GULMOHAR RESIDENCY

Details of Additions & Alterations

Description	Direction	Owners & Developers :	Date :
H-BLOCK-Flat no-3-B2-Type-West facing- Working plan	N	Modi Reality Mallapur LLP Project Name & Phase : Gulmohar Residency	26.10.2022
		Jayapratha Soham Modi N.T.S	Promoted by Modi Properties Pvt Ltd
			Phone:+91-40-66335551

Description	Direction	Owners & developers :	Date :	Promoted by	
				16.09.20	Modi Properties Pvt Ltd
QC-A-FLAT NO 101-PLUMBING PLAN(A2-TYPE)	N 	Modi Rishi Mallapur LLP	Prepared By :	Jayashree	Modi Properties Pvt Ltd
		Project Nip & Phase :	Approved By :	Saham Modi

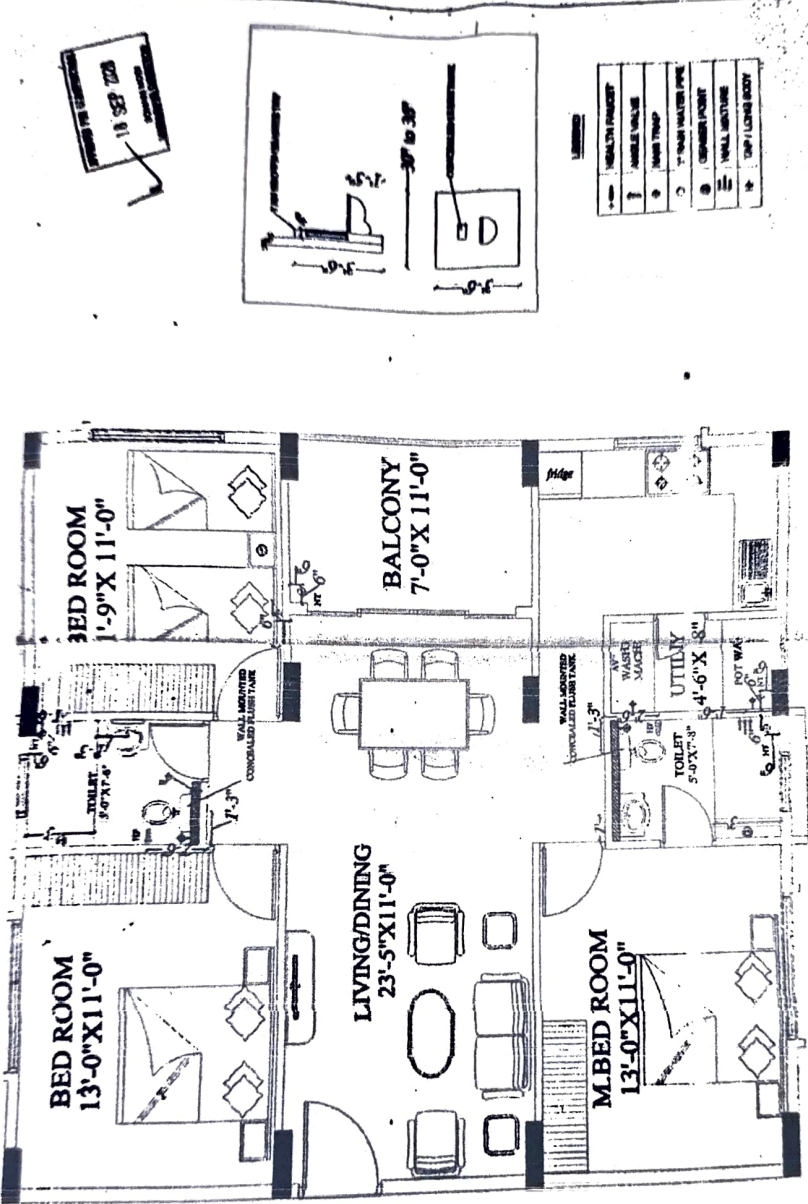
Screeding done on walls upto 12" outside bathroom/utility	☒ Yes ☐ No
Bathroom /utility filled with 4" water for water proof check	☒ Yes ☐ No
Hole packing done around all pipes in ceiling and internal walls	☐ Yes ☒ No
Remarks:

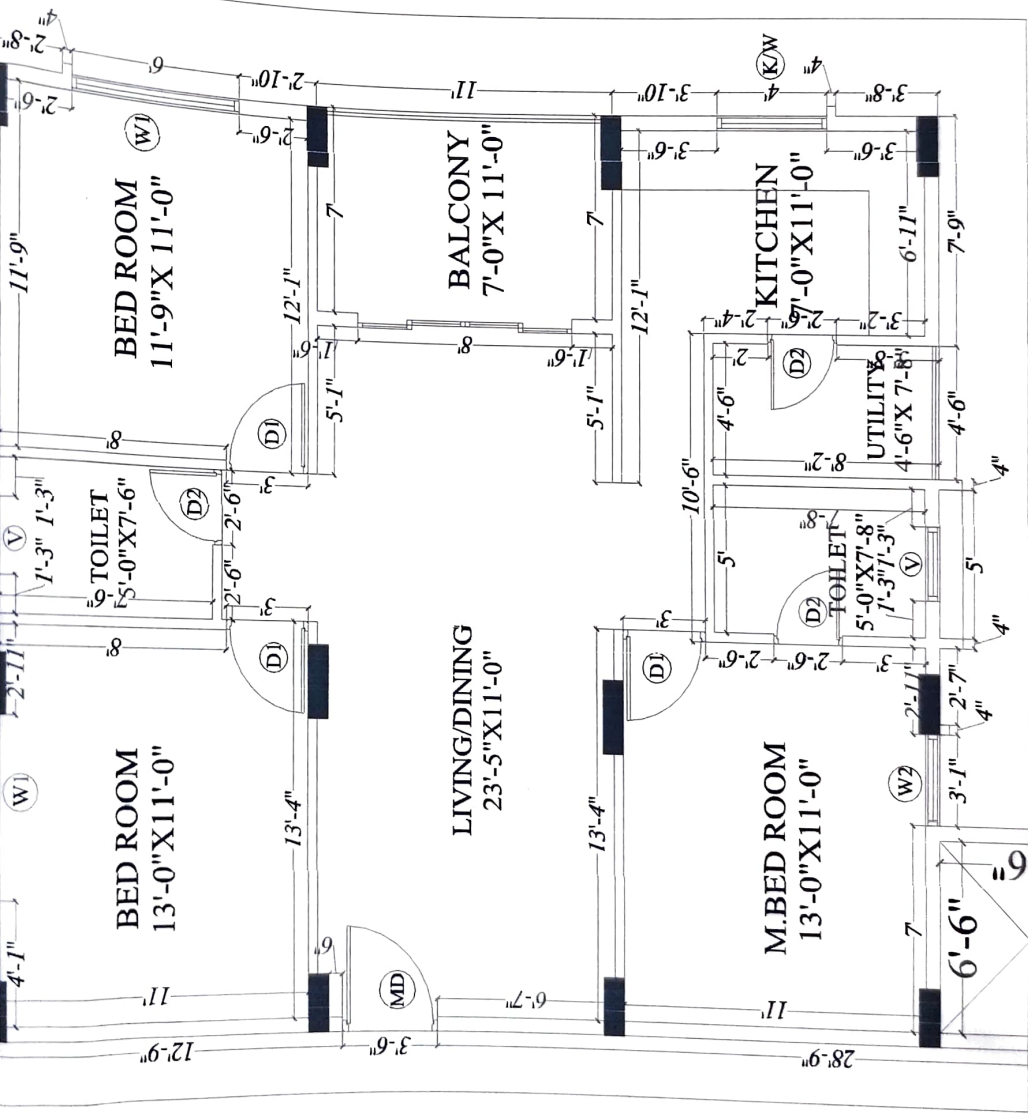
- 1) Gamps electrical extra pt to be in balcony marked in plan.
- 2) Extra/Gamps electrical pt to be in utility ~~balcony~~ wash.
- 3) Gamps ~~extra~~ pt under kitchen platform. for Bio water. to be shifted.
- 4) Gamps extra bed pt to be provided in childrens B. room, and Guest B. room marked in plan.
- 5) 3 no. of Gamps extra pts to be provided in Guest B. room with Sway box marked in plan.
- 6) Shift Gamps switch board from South to East wall marked in plan.

- 1) Wash basin inlet pt to be provided in ~~balcony~~ Dining marked in plan.
- 2) Extra tap pt for dishwasher in utility
- 3) ~~Alarm guard~~ pt to be ^{shifted} ~~provided~~ under kitchen platform

- 1) RCC Kitchen Platform to be casted with laundry 2' 6" from utility wall, granite & sink to be brought by customer.
- 2) utility rcc platform to be casted with company granite and sink to be brought by customer.

- ~~interior wall~~ ~~removing~~ → Wall to be dismantled near Kitchen. marked in Plan
- 2) W-B inlet/outlet Pts near dining marked in Plan.
- 3) Potwash area step to be removed in Master Bathroom.
- 4) kitchen left & exact passage width to be removed marked in Plan.
